**MENDOCINO HISTORICAL REVIEW BOARD
STAFF REPORT**

**JULY 1, 2019
MHRB_2016-0018**

PROJECT DESCRIPTION: A Mendocino Historical Review Board Permit request to demolish, reconstruct, and/or construct the Ferro House, garage, tower, fencing, driveway and other structures. Note: Mendocino Town Plan Appendix 1 lists the site as a Category IIa Historic Resource.

STREET ADDRESS: 45270 Albion Street, Mendocino (APN: 119-217-06)

**HOUSE - EAST ELEVATIONS -
EXISTING & PROPOSED**

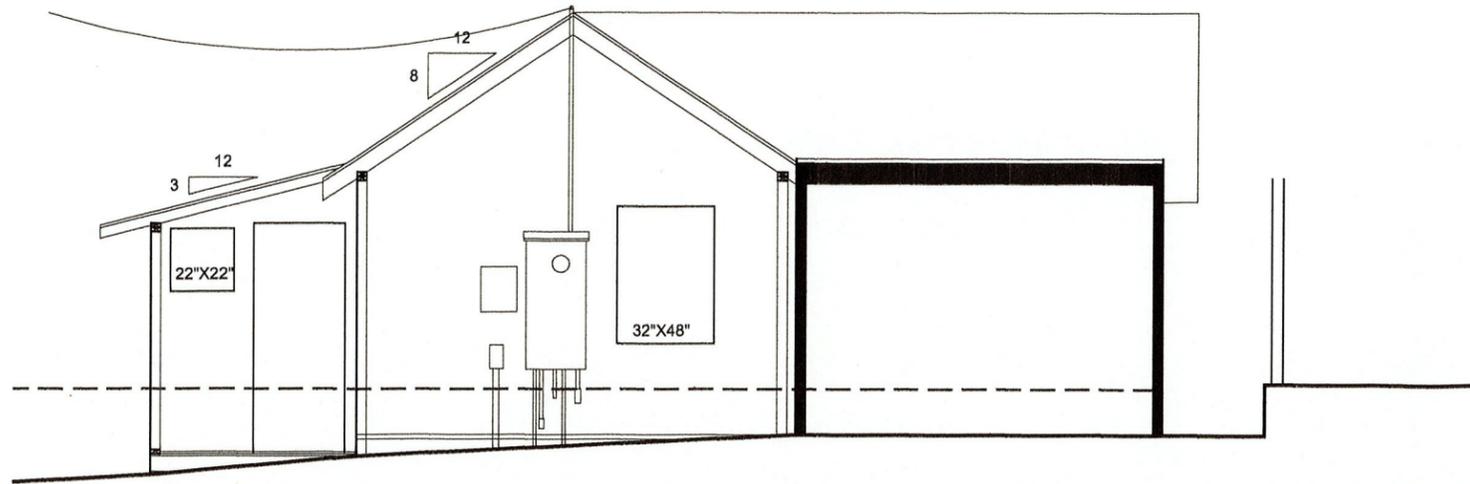
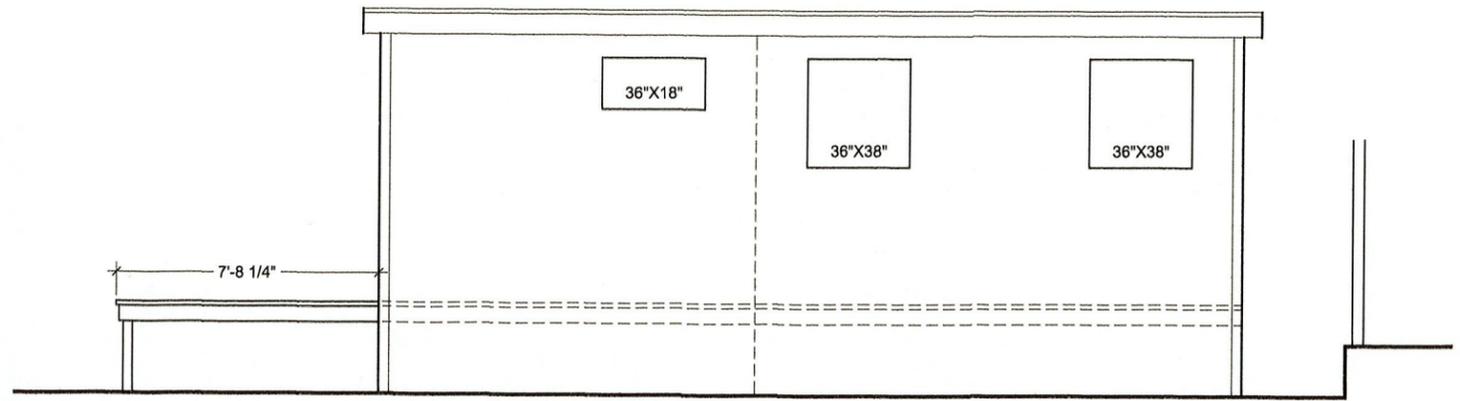
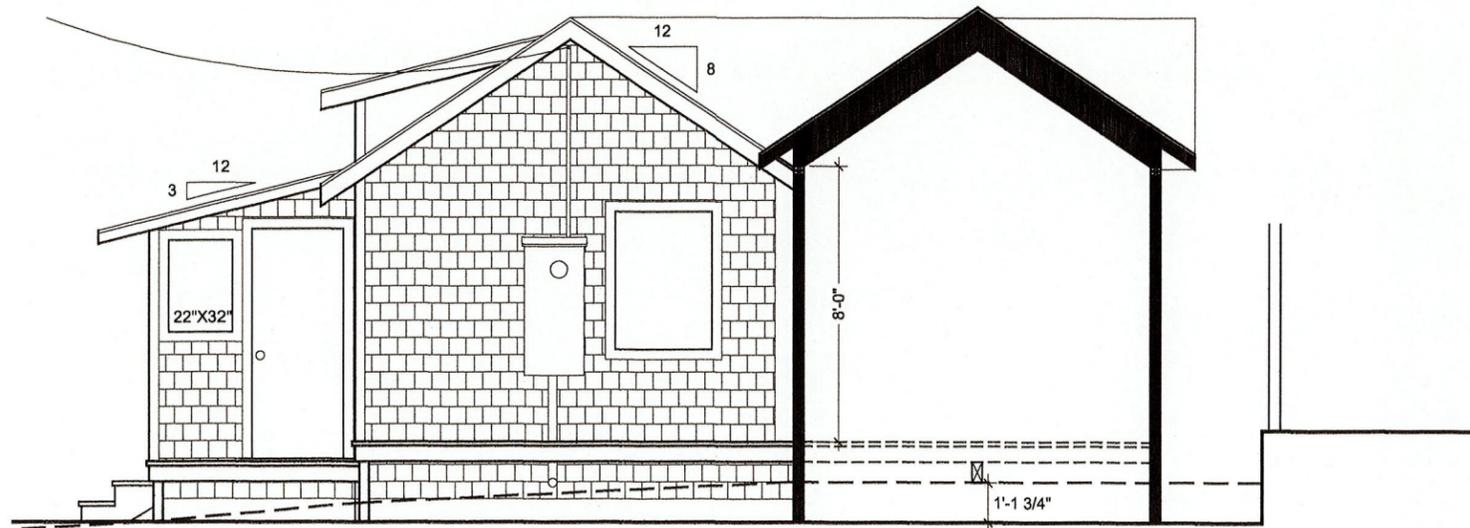
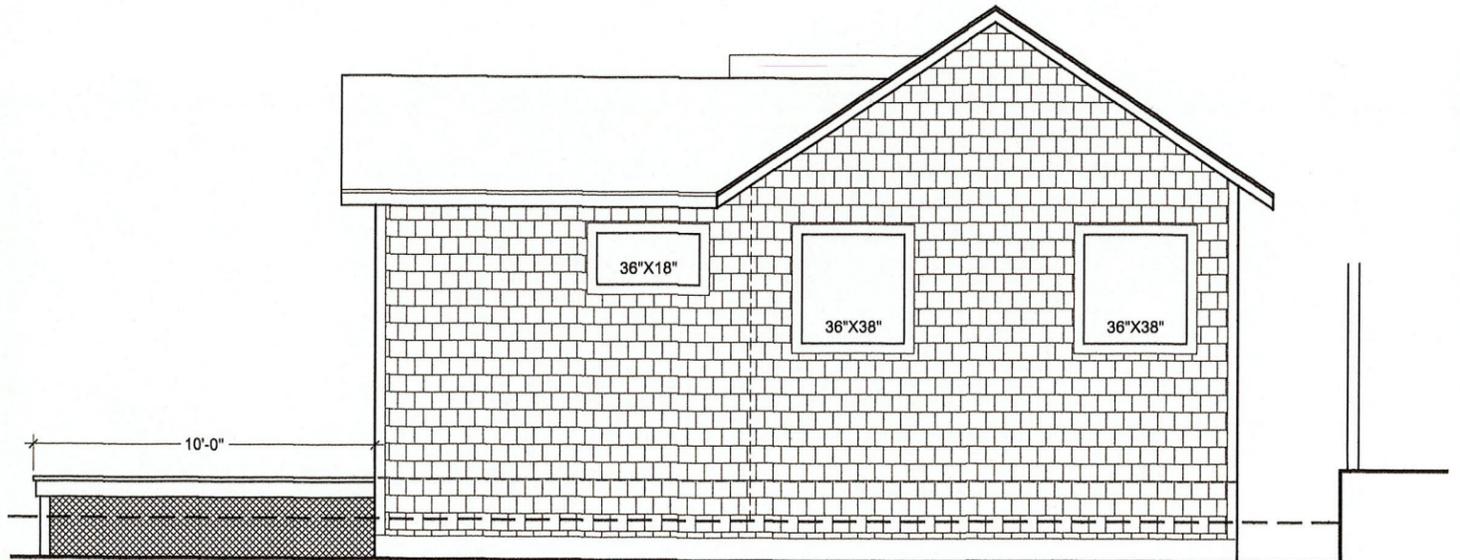
Proposed House Restoration and New Construction. The siding to the house (cabin, mudroom, additions) would be cedar shingles with oil finish to help preserve the material. Redwood trim would be painted forest green. The cabin, mudroom, and additions would be reconstructed in the existing foot print. The rooflines would be reconstructed with the same 8:12 pitch as shown on the as-built plans, except the circa 1980 addition with flat roofs would be rebuilt with a 8:12 pitched gabled roof running east west. Asphalt shingles would be used throughout. Existing windows would be replaced with wood-frame windows having mostly the same size, style, and shape. Windows would be placed within the proposed dormers. Doors would be replaced with painted fiberglass doors. See Sheet No.'s A2 through A5 for existing and proposed elevations of the house.

10. To the satisfaction of the Director of Planning and Building Services, exterior house building plans shall provide sufficient detail for the successful reconstruction of the cabin, mudroom, and additions with an 8:12 gabled roofline.

12. The House, Tower, and Garage trim shall be redwood and painted with a forest green color.
 13. The House, Tower, and Garage shall be clad with cedar shingles as shown on the elevations.

SHEET NAME:
**TOWER NORTH & EAST ELEVATIONS -
EXISTING & PROPOSED**

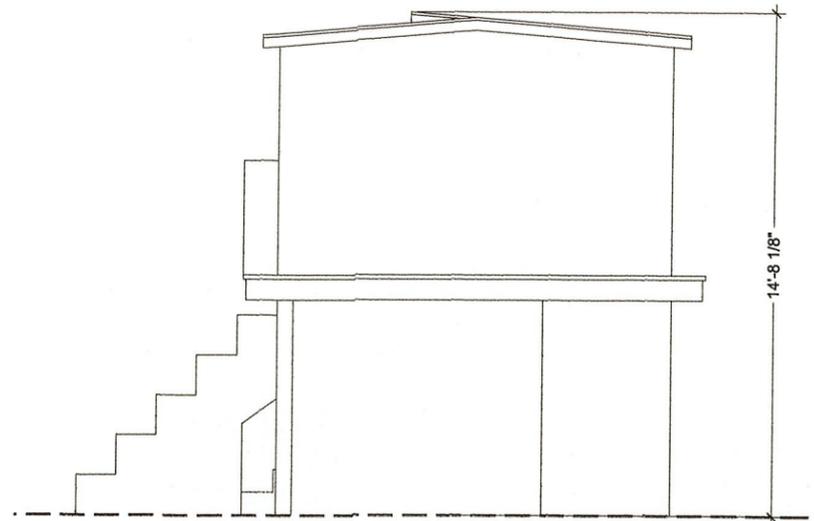
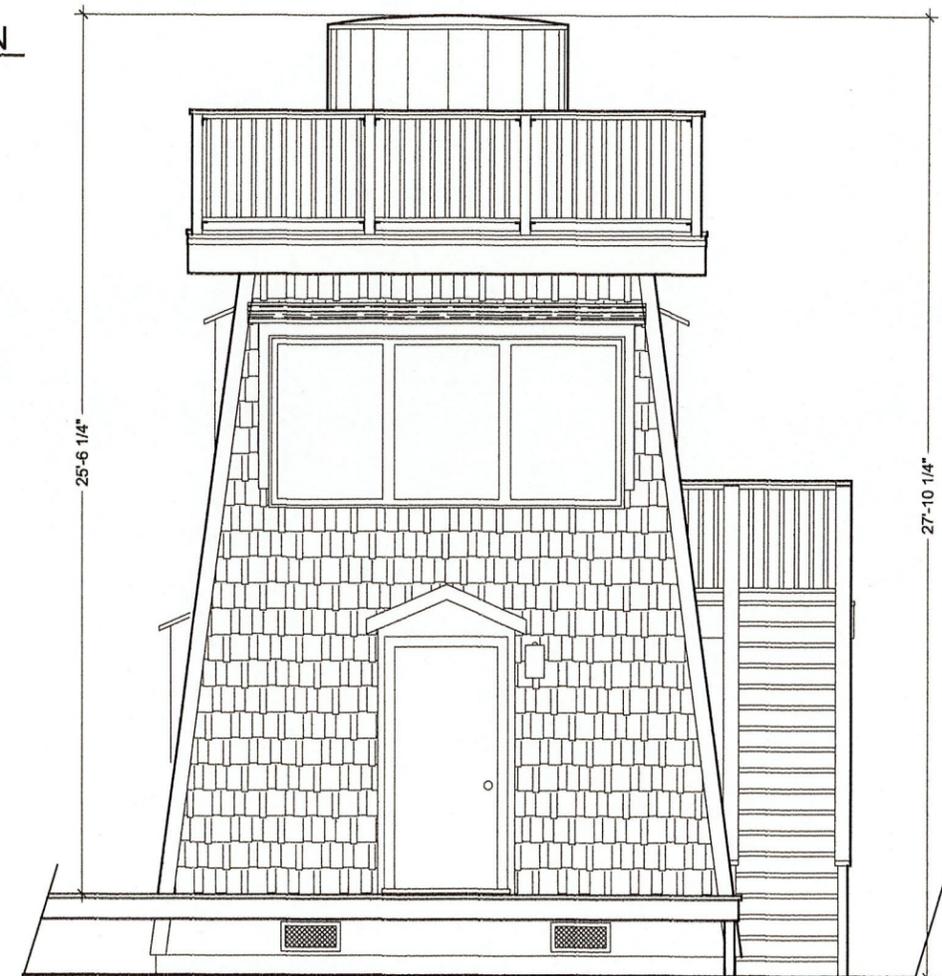
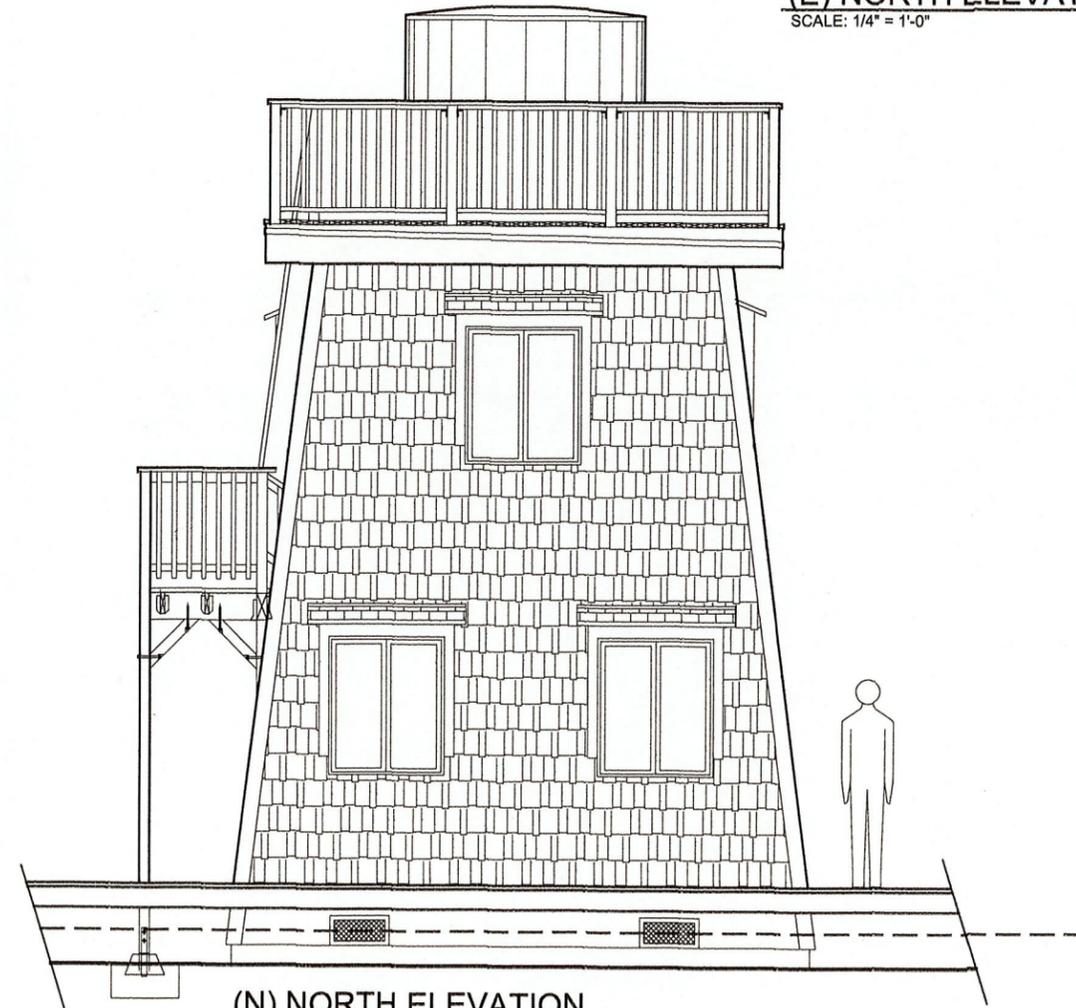
Existing Tower. The circa 1900 water tower is 14 feet in height and irregularly shaped (See Sheet No.'s A6 and A7 Tower Elevations). It has a footprint of approximately 200 square feet and has three entrances, two on the primary level, and one on the second level, with both interior and exterior stair cases to the second level. The overall condition of the tower is poor (CHRC 2016).

As an accessory structure, the proposed 28 foot tall tower footprint would be 290 square feet. The siding on the tower would be cedar and the trim would be painted forest green. The tower would have an exterior door on each level with an external staircase projecting from the building footprint. A new 2,800-gallon water storage tank would be located atop the tower. The proposed water storage tank exterior would be lined with redwood slats and enclosed with metal bands. The proposed tower would be 28 feet in height above grade including the additional height of the water storage tank.

(E) & (N) GARAGE PLAN

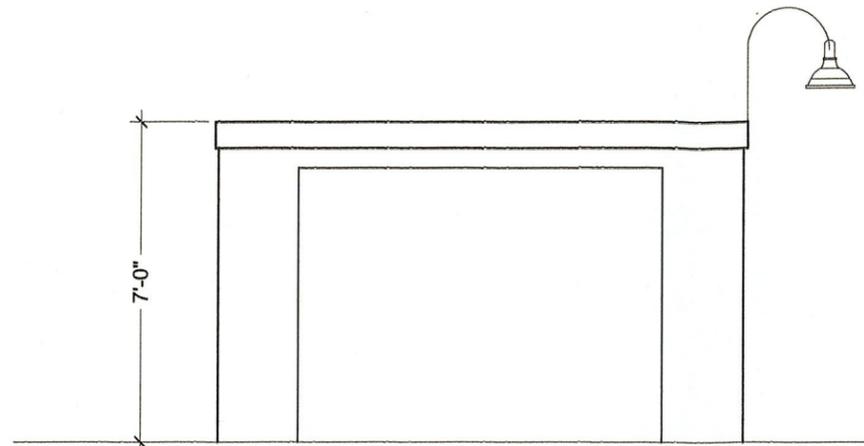
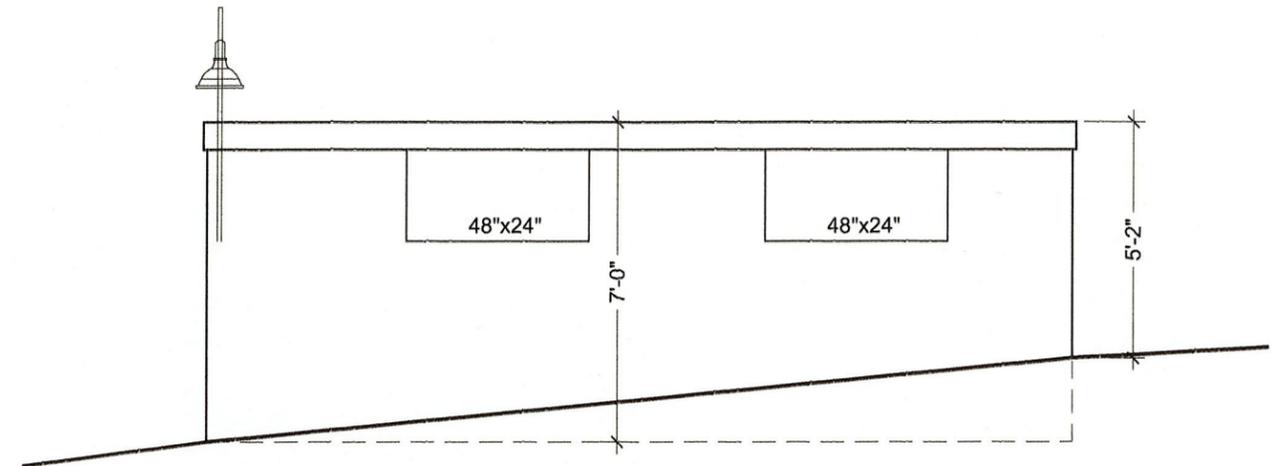
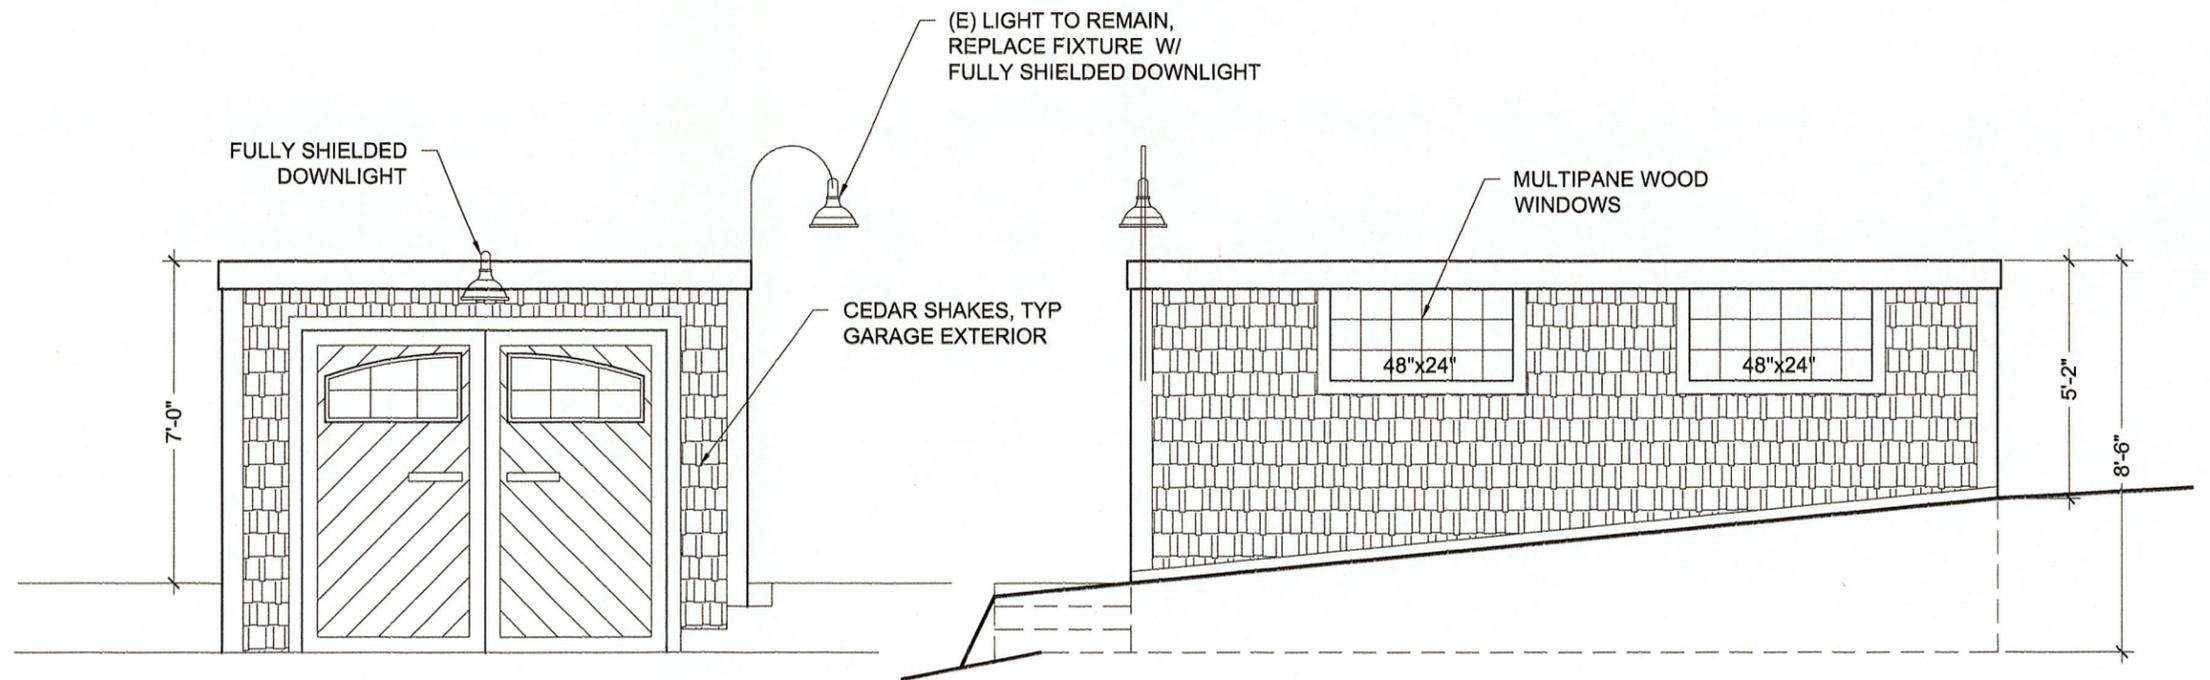
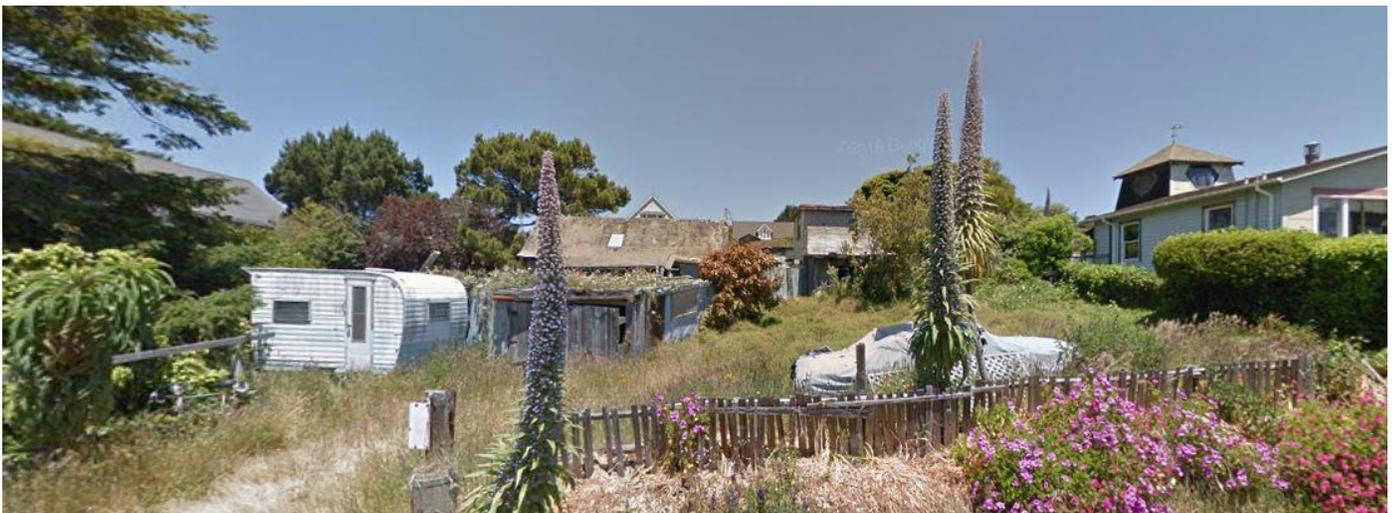
Existing Garage. The garage is approximately 12 feet by 20 feet and is built with a mixture of 2 inch by 12 inch wood boards, plywood, and corrugated metal siding (See Sheet No. A8 Garage Elevations and Floorplan). The south elevation is 7 feet tall; the north wall varies between 5.3 feet and 5.6 feet tall. It has a flat, sheet-metal roof covered in tar. The garage stands on a post foundation and has a dirt floor. A large, now defunct concrete lined well has been dug into the center of the floor. Wooden framework around the well has rotted extensively and has exposed tunneling below the floor. The garage door is composed of vertical 2 inch by 12 inch on-gate hinges. A rectangular window opening on the east wall has been covered by corrugated fiberglass paneling. The overall condition of the garage is poor (CHRC 2016).

Proposed Garage Restoration. The siding on the garage would be cedar shingles with redwood trim painted forest green (See Sheet No. A8 Garage Elevations and Floorplan). The flat roof of the garage would be rebuilt to the same shape and style. The floor of the garage would have the pit and tunneling removed and then covered with a cement slab. Windows on the garage would be replaced with multipane wood windows as shown on the elevations.

11. To the satisfaction of the Director of Planning and Building Services, exterior garage building plans shall provide sufficient detail for the successful reconstruction of the garage with a flat roofline.
